Number B65-0285-00

SERVICE BULLETIN

Ride: ZUMUR

Subject: Chair Hanger Wear Limits

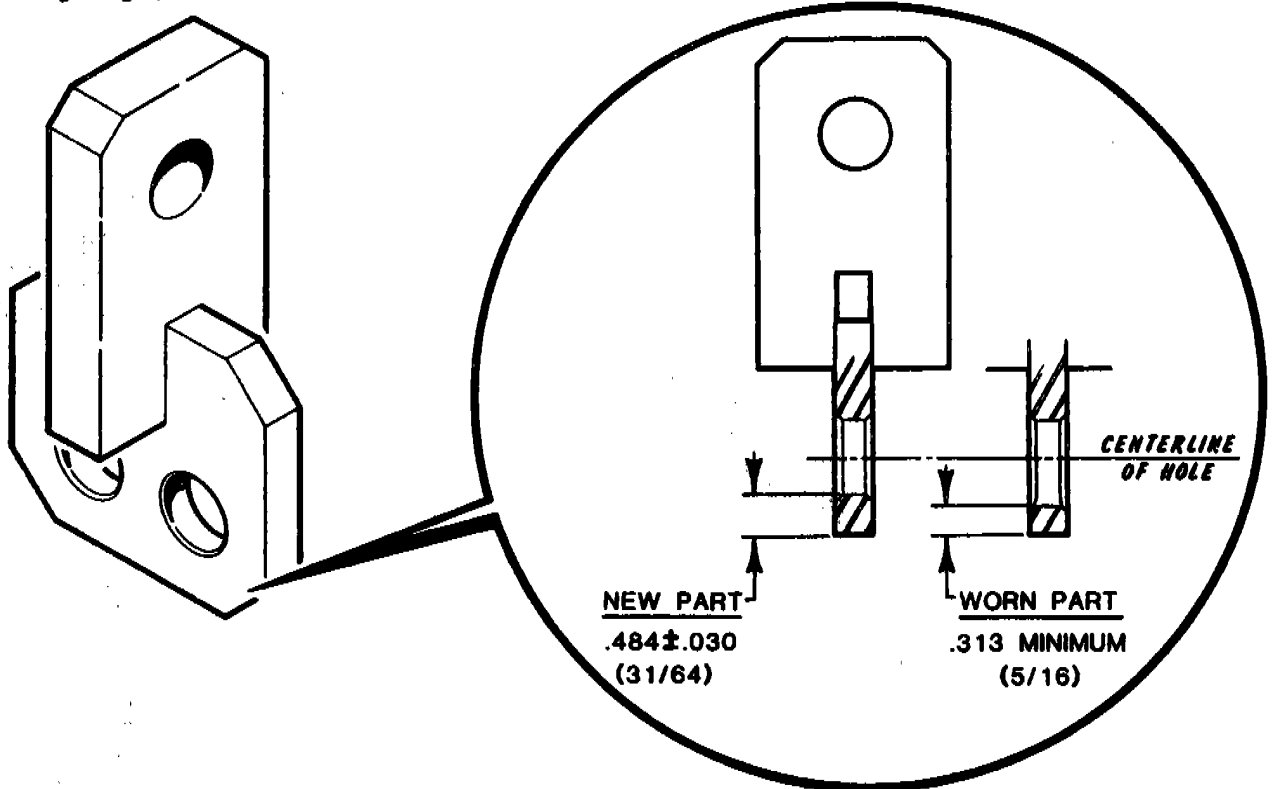
Measure the edge distance on all chair hangers as shown. If the dimension is less than .313 (5/16"), do not operate the ride until the chair hanger is replaced.

New chair hangers are available from CHANCE MANUFACTURING COMPANY, INC. Order part number 361-32706.
